**ADDENDUM NO. 1
TO THE
DRAWINGS AND SPECIFICATIONS
FOR LINCOLN LAKE DAM REHABILITATION
PROJECT #300DM-74011-09-C1**

ISSUE DATE: December 11, 2024

This **Addendum No. 1** to the drawings and specifications shall supplement, amend and become a part of the bidding documents, plans and specifications. All bids and construction contracts shall be based on these modifications to the original contract documents.

EXISTING SITE IMPROVEMENTS PLAN

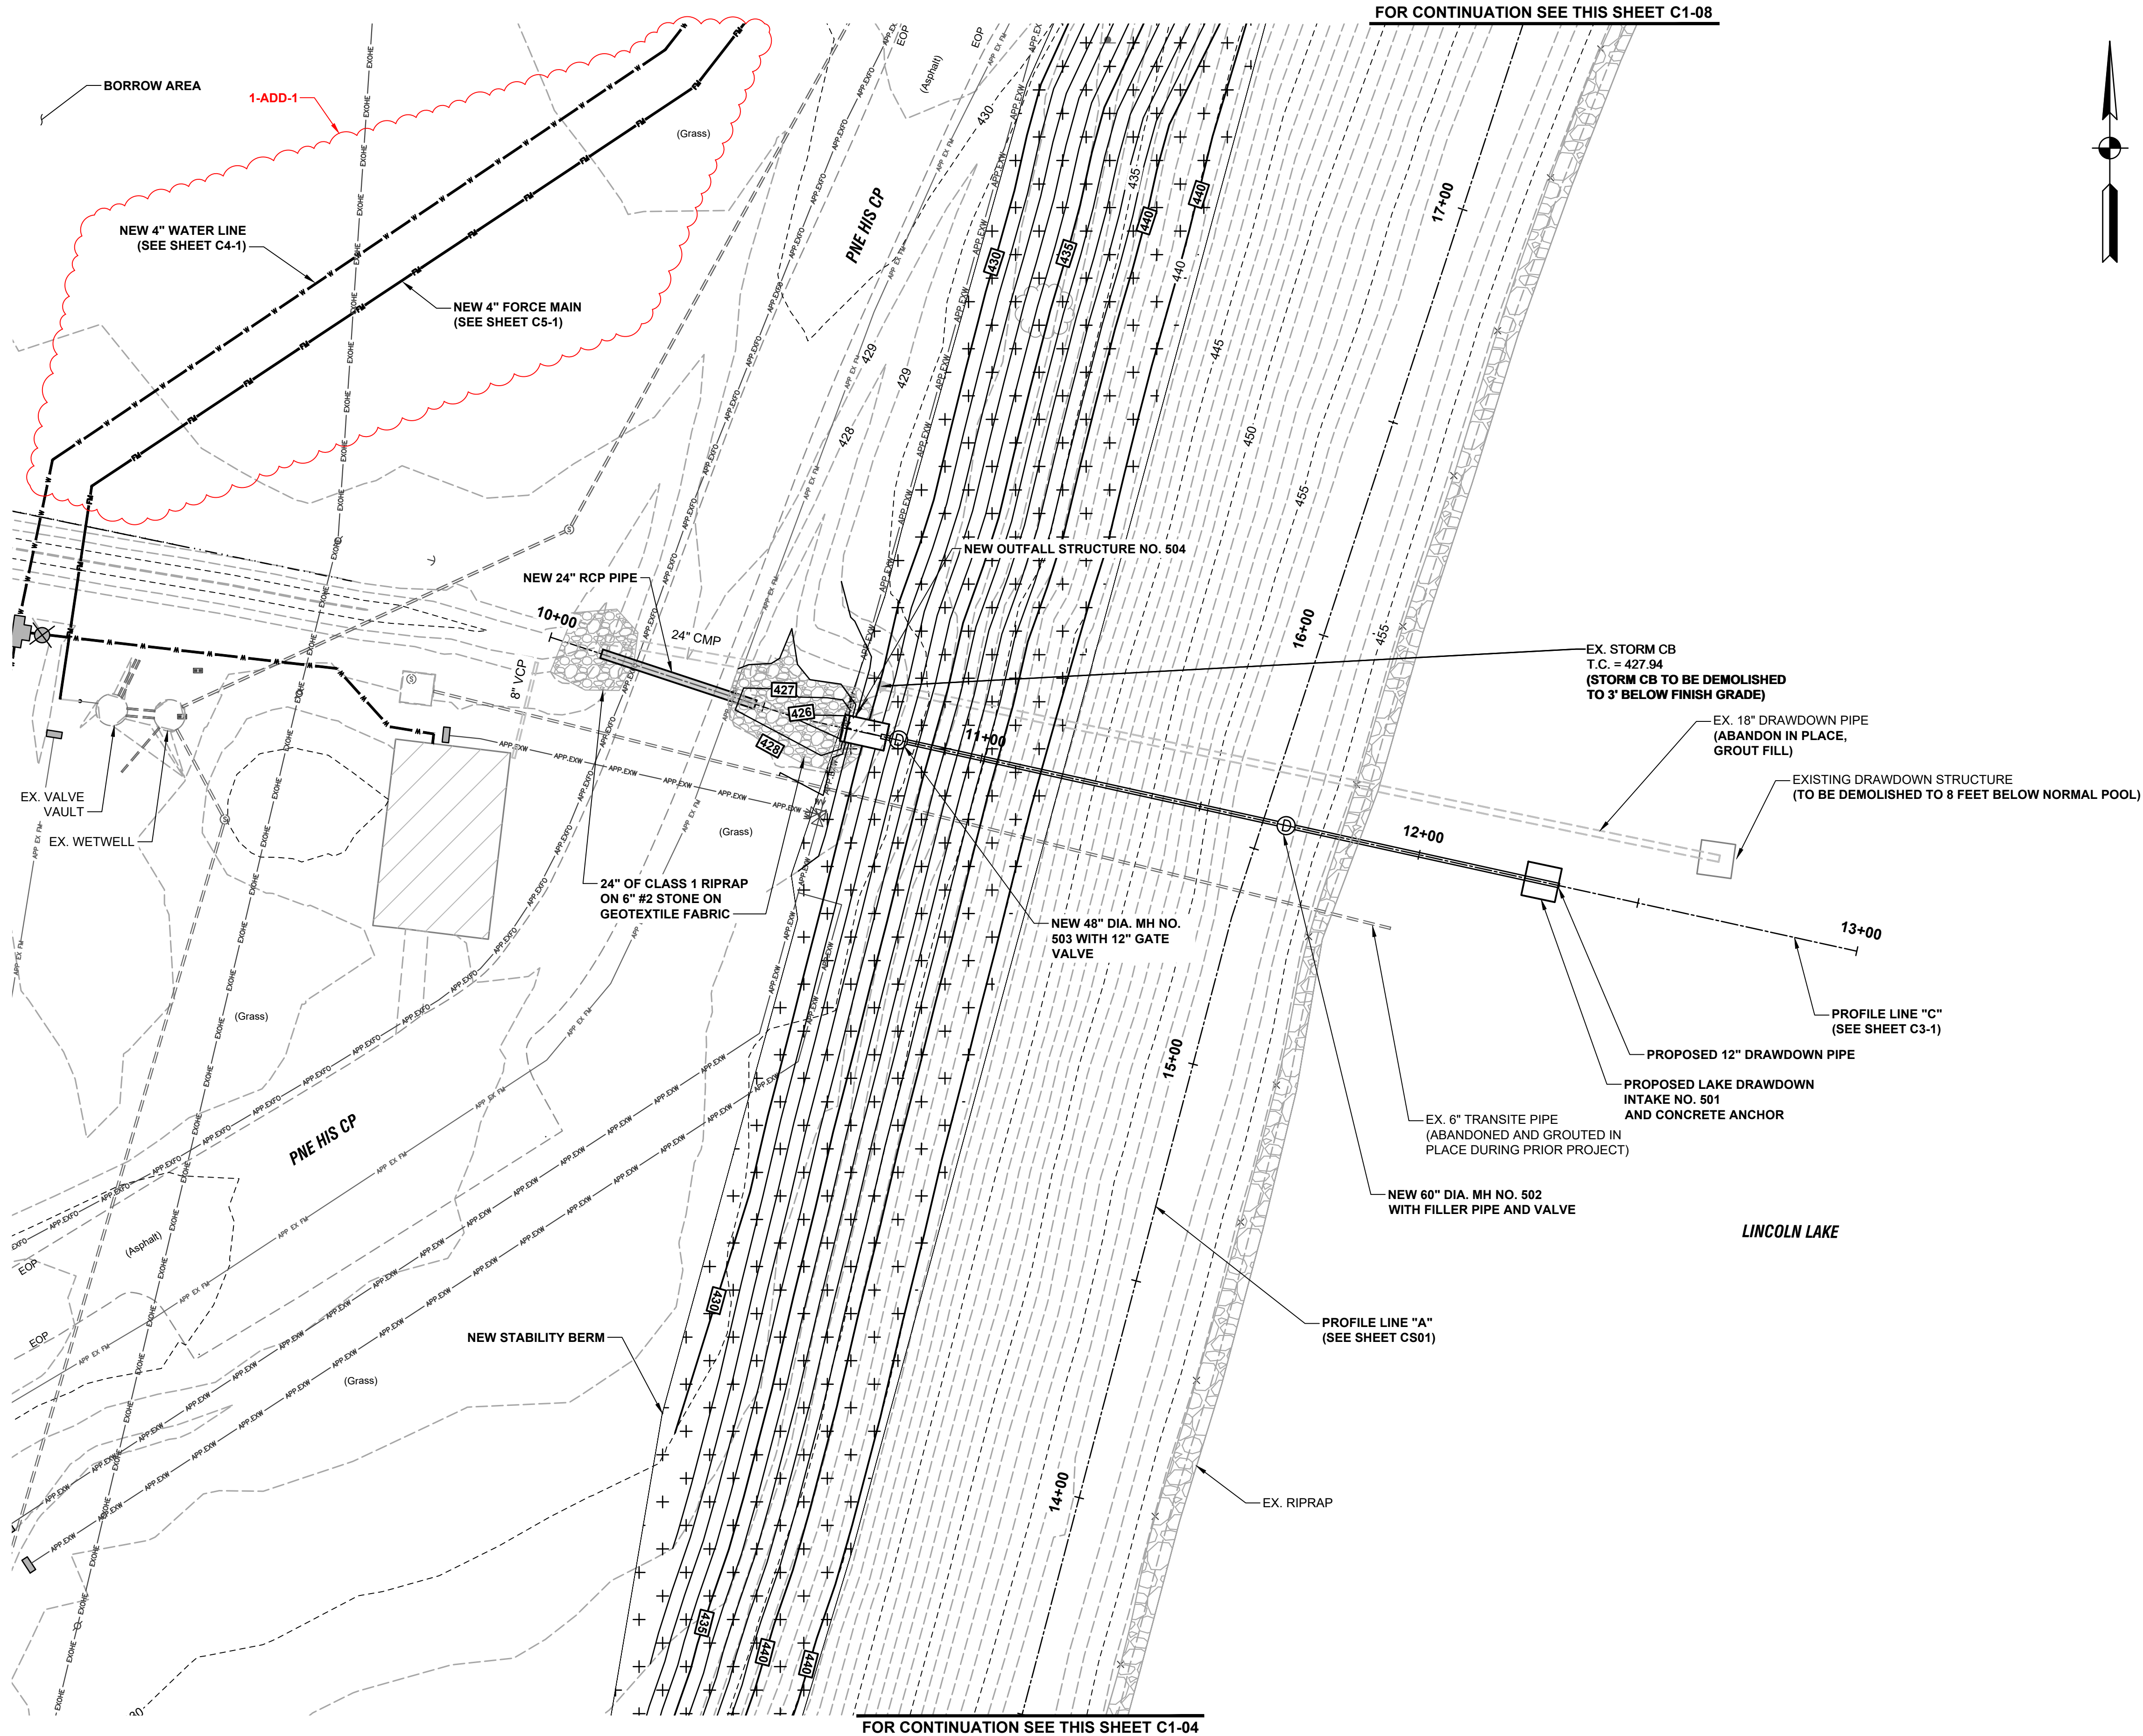
- A. Attached please find a copy of the pre-bid meeting sign-in sheet, pre-bid meeting agenda and minutes.
- B. Relocated utility lines and associated work as shown on the revised drawings
 - 1. EC-3
 - 2. C1-02 to C1-03
 - 3. C1-07 to C1-10
 - 4. C4-1 to C4-2
 - 5. C5-1
- C. Utility lines can be open cut or directionally drilled. The relocated water line is located under an asphalt parking lot. If the pavement is cut for the utility line, all work except is to be included in the lump sum price except for the HMA which can be included as part of the supplemental unit prices.
